Groundwater Application Review Summary Form

Application # G- 18849

GW Reviewer Travis Brown Date Review Completed: 8/16/2019

PUBLIC INTEREST REVIEW FOR GROUNDWATER APPLICATIONS

Hydrograph – MARI 1065 (TD = 178 ft) and MARI 51725 (TD = 347 ft)

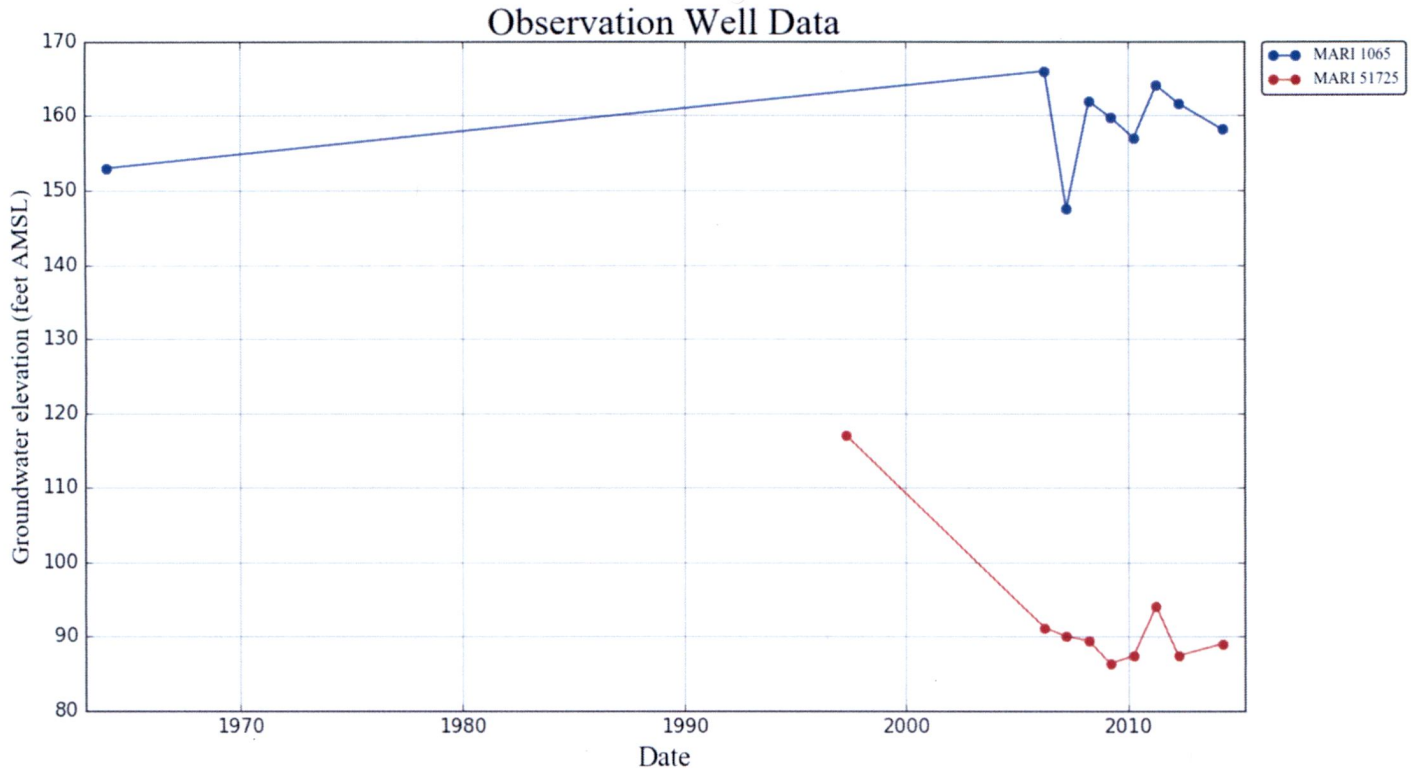
Basis for aquifer hydraulic connection evaluation: The elevation of groundwater in the proposed POA and nearby observation wells with comparable construction is similar to the elevation of nearby surface water (see Hydrograph, attached). Groundwater surface mapping in this area indicates that groundwater is generally flowing toward and discharging into the small streams (particularly SW 2) which drain the terrace above the modern Willamette River floodplain (Gannett and Caldwell, 1998).

Hydrograph – Spring Water Levels – Wells Greater Than 250 ft Total Depth

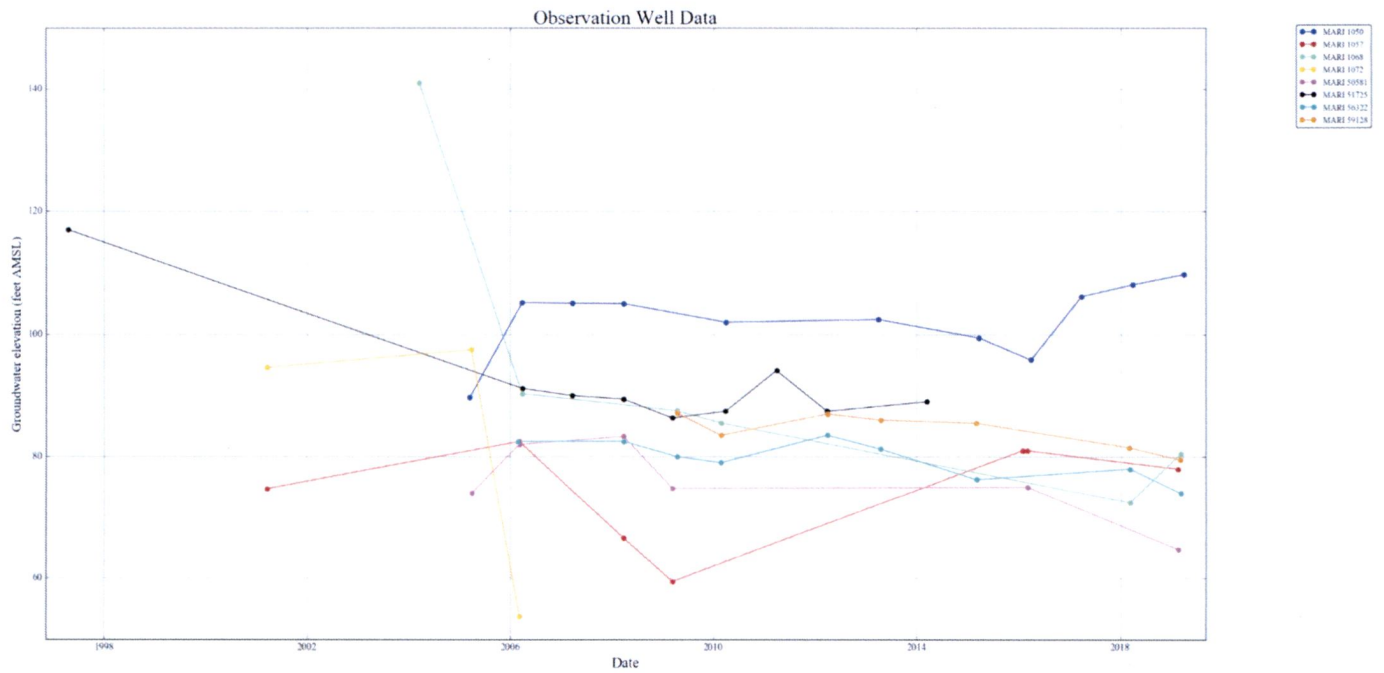
Water levels from nearby wells completed in the deeper (greater than 250 ft bls) confined aquifer indicate modest (5-20 ft) declines over the past two decades (see Hydrograph, attached).

Stream Depletion Analysis – SW 1 (Unnamed Tributary to Willamette River)

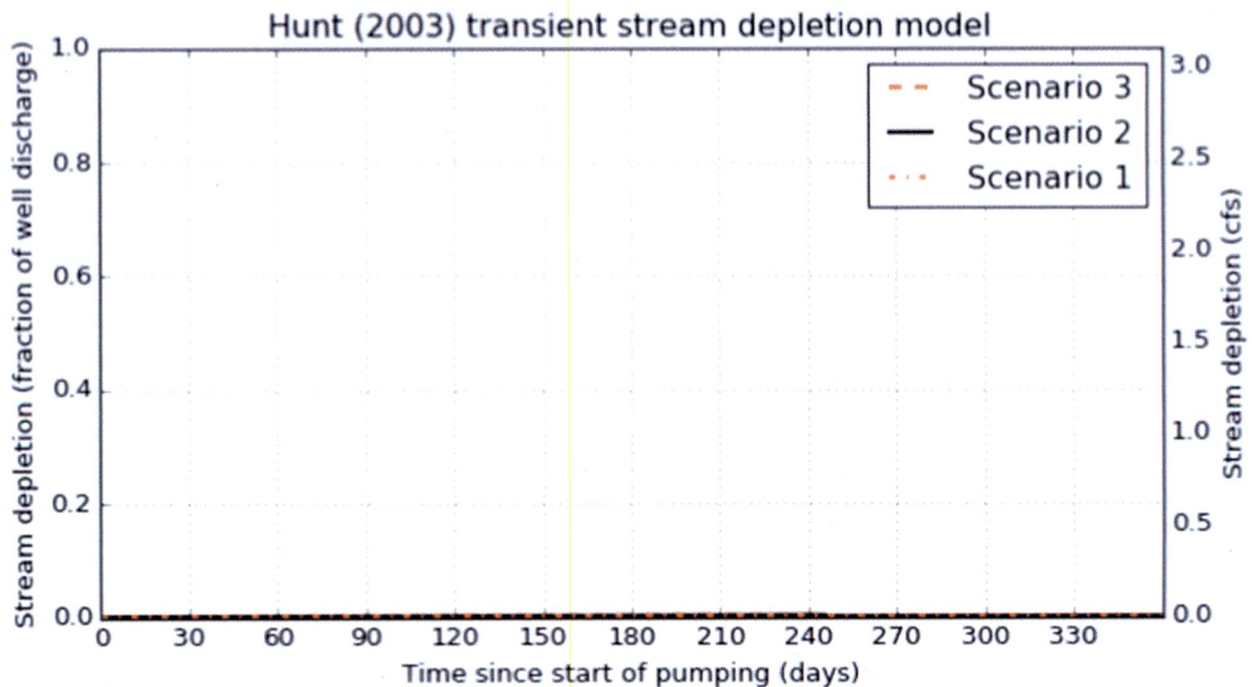
Potential depletion of SW 1 and 2 due to pumping of the proposed POA was estimated using the Hunt 2003 analytical model. Hydraulic parameters used for the model were derived from regional data or studies of the hydrogeologic regime (Pumping Test Reports, OWRD Well Log Query Report, Conlon et al., 2003, 2005; Iverson, 2002; McFarland and Morgan, 1996; Woodward et al., 1998) or are within a typical range of values for the parameter within the hydrogeologic regime (Freeze and Cherry, 1979; Domenico and Mifflin, 1965). See attached Stream Depletion Analyses for the specific parameters used in the analyses.

Based on the preponderance of evidence, the Hunt 2003 analytical model results indicate that depletion of (interference with) SW 1 and 2 due to pumping of the proposed POA is anticipated to be much less than 25 percent of the well discharge at 30 days of continuous pumping.

Stream Depletion Analysis – SW 2 (Mission Creek)

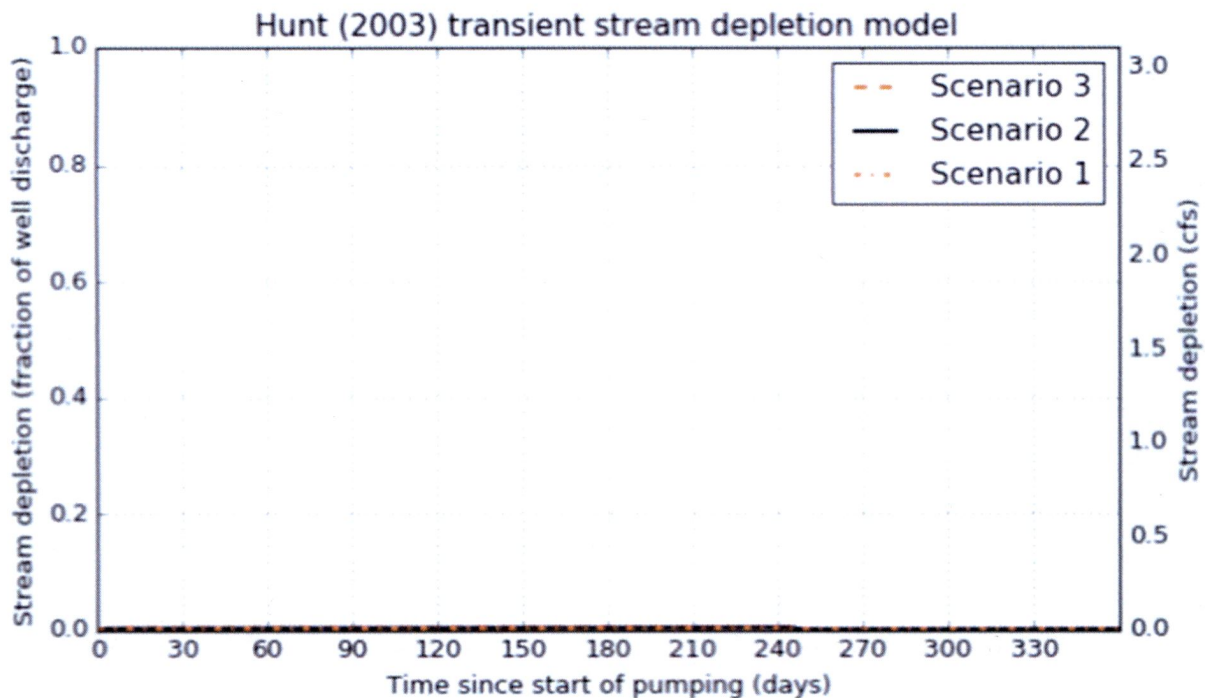
Comments: C3a: The combined (authorized plus proposed) rate of appropriation (3.1056 cfs) is greater than 1 percent (0.01 cfs) of the natural flow that is equaled or exceeded 80 percent of time (1.00 cfs) for the CHAMPOEG CR > WILLAMETTE R – AT MOUTH Water Availability Basin (WAB) (see Water Availability Tables, attached). Per OAR 690-09-0040(c), PSI with SW 2 is assumed.

C6. **SW / GW Remarks and Conditions:** **PSI with SW 2 (Mission Creek) is assumed based on the combined rate of appropriation. Permit G-18143 was not evaluated for PSI with Mission Creek based on the natural flow in CHAMPOEG CR > WILLAMETTE R - AT MOUTH WAB. Because the authorized rate of appropriation (1.78 cfs) associated with Permit G-18143 is in excess of 1 percent (0.01 cfs) of the flow that is equaled or exceeded 80 percent of time (1.00 cfs) for the CHAMPOEG CR > WILLAMETTE R - AT MOUTH WAB, any additional proposed rate of withdrawal for the proposed POA (MARI 51725) would be assumed to cause PSI with SW 2 (Mission Creek).**
